Text Amendment #2019-0004
Rezoning #2019-0005
CDD Concept Plan #2019-0002
Greenhill South CDD – 600 South Pickett Street

The applicant requests approval of a Text Amendment, Map Amendment (rezoning), and a CDD Concept Plan to allow for the future redevelopment of a 6.2-acre site with new streets, open space, and new buildings of varying densities, heights and uses.

**Text Amendment #2019-0004, Rezoning
#2019-0005, Coordinated Development
District Conceptual Design Plan #2019-0002
600 South Pickett Street**

Figure 1: Preliminary CDD Concept Plan

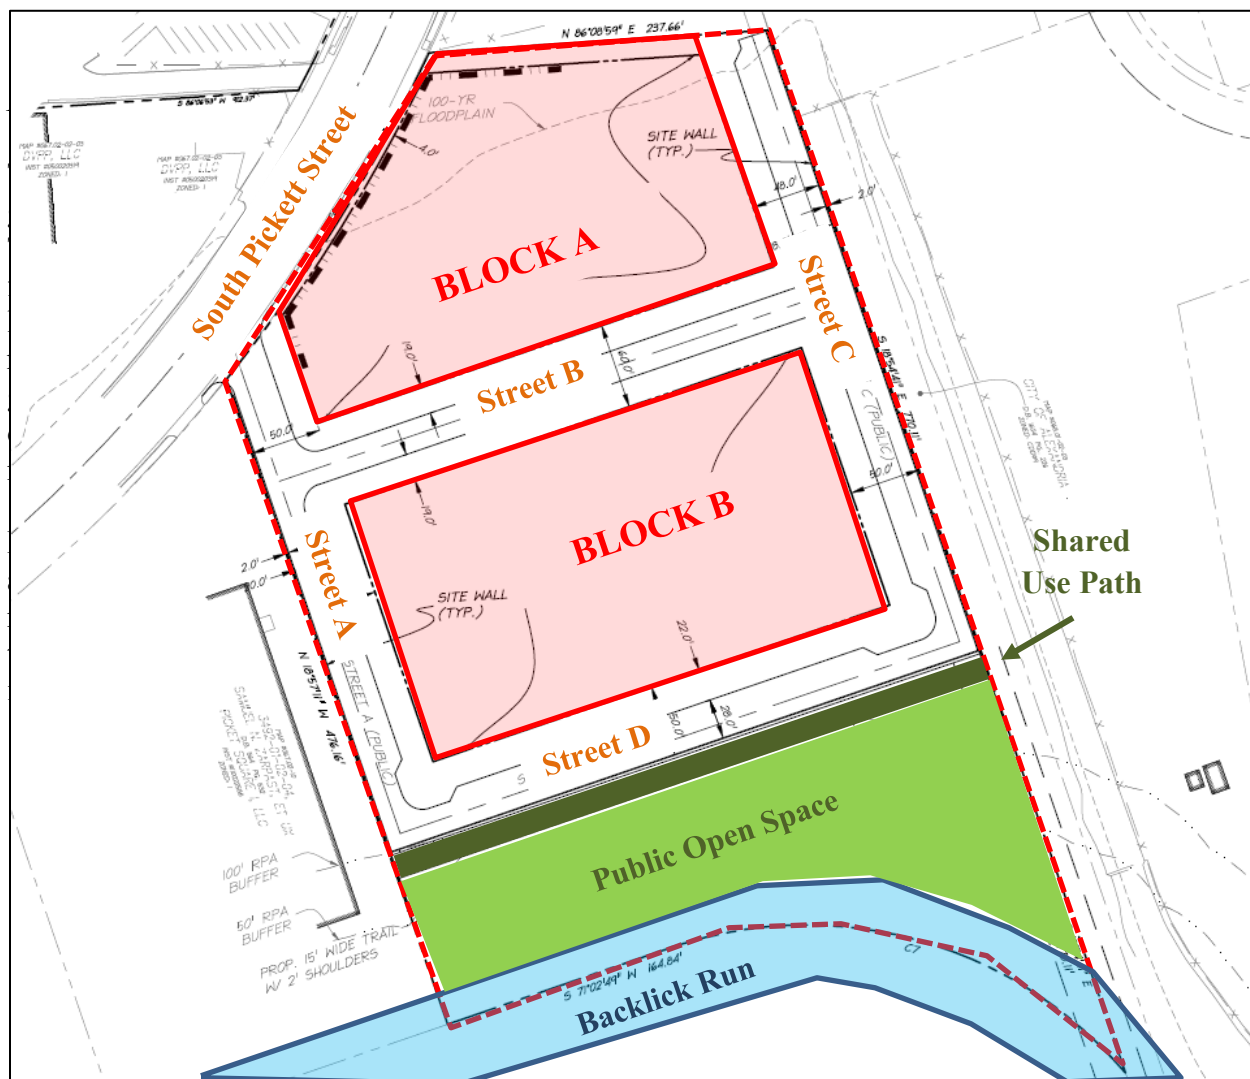
- 11. On the final CDD Concept Plan submission, provide the overall FAR for the entire site, including both phases as well as all areas to be dedicated to the City for public streets or public open space. (P&Z)

- 14. Depict on the final CDD Concept Plan submission that retail/commercial uses extend the entire length of the western side of Block A, consistent with the Eisenhower West Small Area Plan. (P&Z)

- 15. Depict on the final CDD Concept Plan submission the shared-use bridge with a minimum clear width of 10 feet connecting from the east end of the trail shown on the plans at the eastern property line to the closest feasible landing point adjacent to the western property line of Armistead Boothe Park. (T&ES)(P&Z)

17. On the final CDD Concept Plan, revise the size of the existing RCP pipe from the 48-inch size listed on the preliminary CDD Concept Plan to the 42-inch size listed in City records. Sanitary sewer outfall analyses in future DSUP submissions should account for this revision. (T&ES)

18. Add a note on the final CDD Concept Plan indicating that curb lines are for illustrative purposes only. (P&Z)
19. The grade differences between the CDD Concept Plan area and abutting properties depicted the preliminary CDD Concept Plan shall be minimized to the greatest extent feasible to the satisfaction of the Directors of Planning & Zoning and Transportation & Environmental Services. Such adjustments of grade shall be depicted on the final CDD Concept Plan if they requested prior to or concurrent with said submission. (P&Z)(T&ES)

20. Add to the final CDD Concept Plan submission a new plan sheet that depicts how the future new buildings, streets, and other improvements at the site will be phased. The applicant may request administrative approval of revised project phasing, without the need for public hearings, subsequent to approval of the final CDD Concept Plan to the satisfaction of the Directors of Planning & Zoning and Transportation & Environmental Services. If revised project phasing is requested subsequent to the final CDD Concept Plan approval, the applicant shall provide a revised phasing plan illustration upon request by the Directors. (P&Z)
